SERVICE INFO

Replacing tensioner pulleys 531 0037 10 and 531 0353 10 (front end accessory unit drive) in 531 0241 10

INA 0061

Image 1: Illustration of the individual tensioner pulleys and their differences

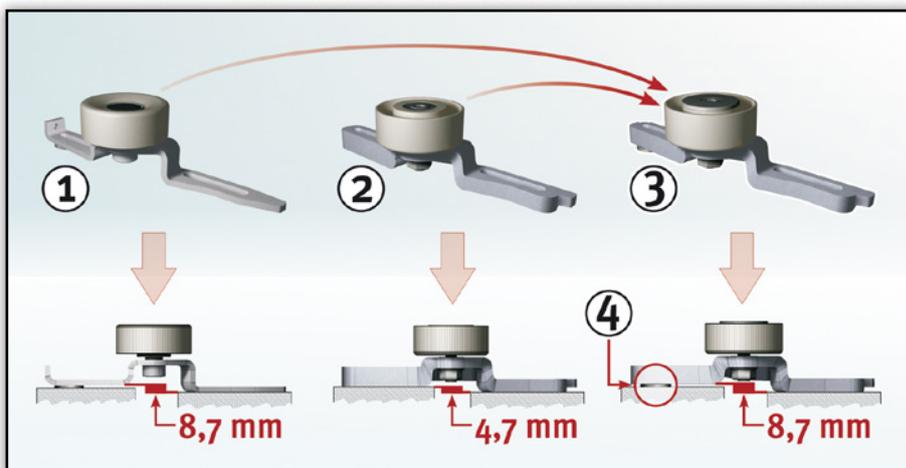
The two tensioner pulleys with part numbers 531 0037 10 and 531 0353 10 (installed in the front end accessory unit drive) are now redundant; they have been replaced by part number 531 0241 10.

- (1) 531 0037 10
- (2) 531 0353 10
- (3) 531 0241 10
- (4) Washer 8.4x19x4 mm

To offset the difference in height, a washer measuring 4 mm in thickness is included with tensioner pulley 531 0241 10.
